Technical Service Information

THM 4L60 (700-R4) ELECTRONIC SPEED SENSOR ADDED TO TRANS

CHANGE: Electronic Speed Sensor added.

Figure 1

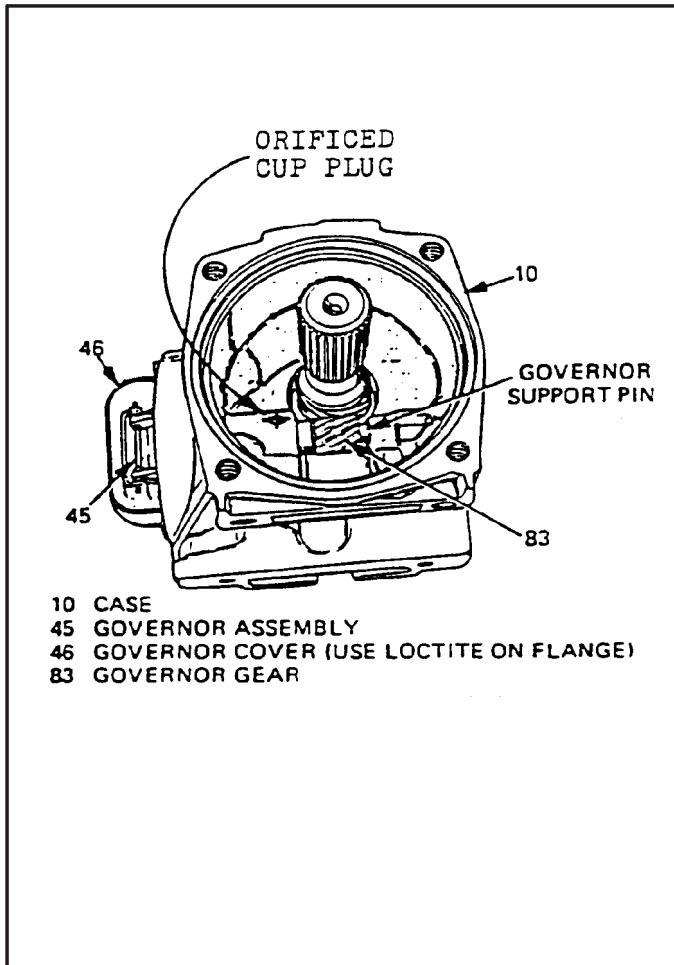
3. Transmission Case (10), the orificed cup plug installed in the governor bore which provides lubrication to the extension housing bushing when the Speed Sensor Rotor is used, see Figure 1. This lube was normally provided by the spinning speedometer driven gear teeth throwing oil to the bushing. When the speedometer gear is replaced with a Rotor the forced lube of orificed cup plug is needed.

Figure 2

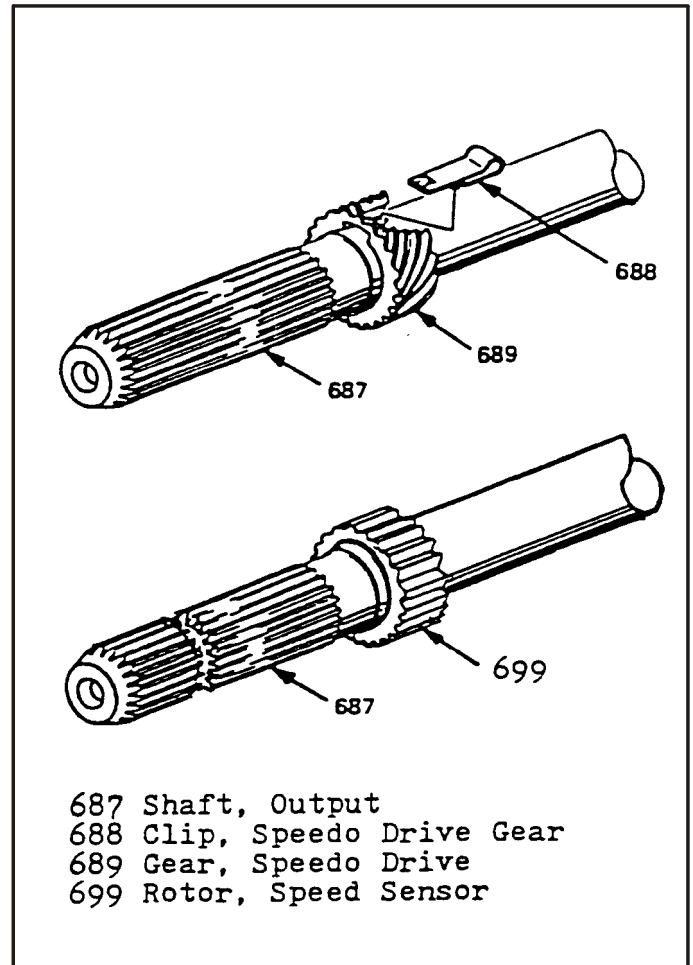
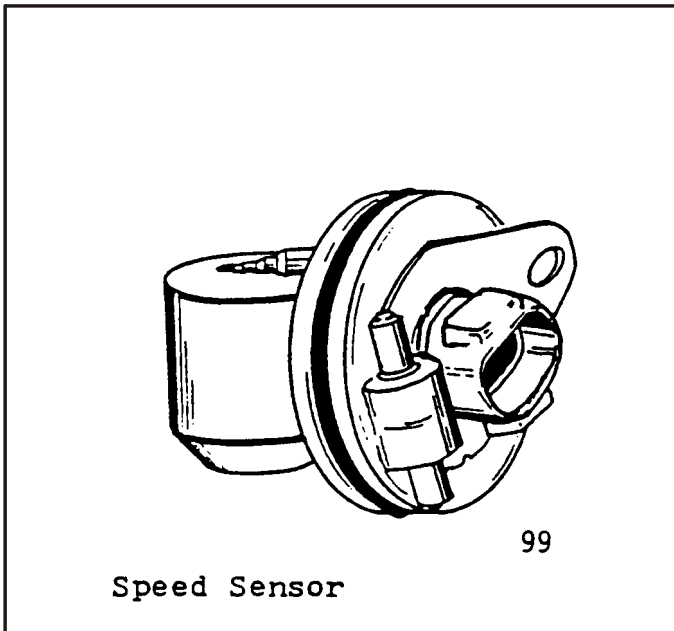
REASON: The Speed Sensor provides an extremely accurate signal which is used by the ECM to provide anti-skid braking. The Speed Sensor and Rotor replace the speedometer adapter and speedometer drive gear (see Figures 2 and 3). Current usage is on C trucks with 4.3L, 5.0L, 5.7L, (Gas) and 6.2L (Diesel) engines. This change went into production July 17, 1986.

PARTS AFFECTED: 1. The speedometer adapter and speedometer drive gear are replaced by the Speed Sensor (99) and Rotor (699). See Figures 2 and 3.

Figure 4

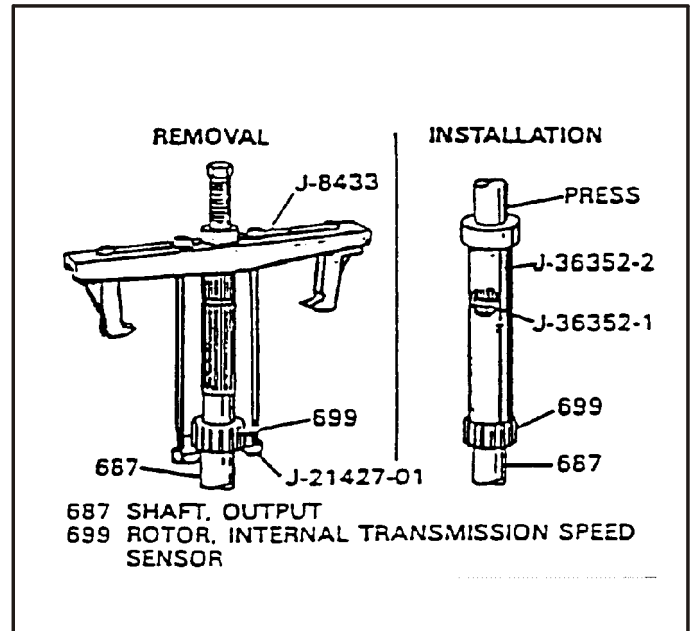
2. Output Shaft (687), has an added groove to remove and install the Rotor. See Figure 4.
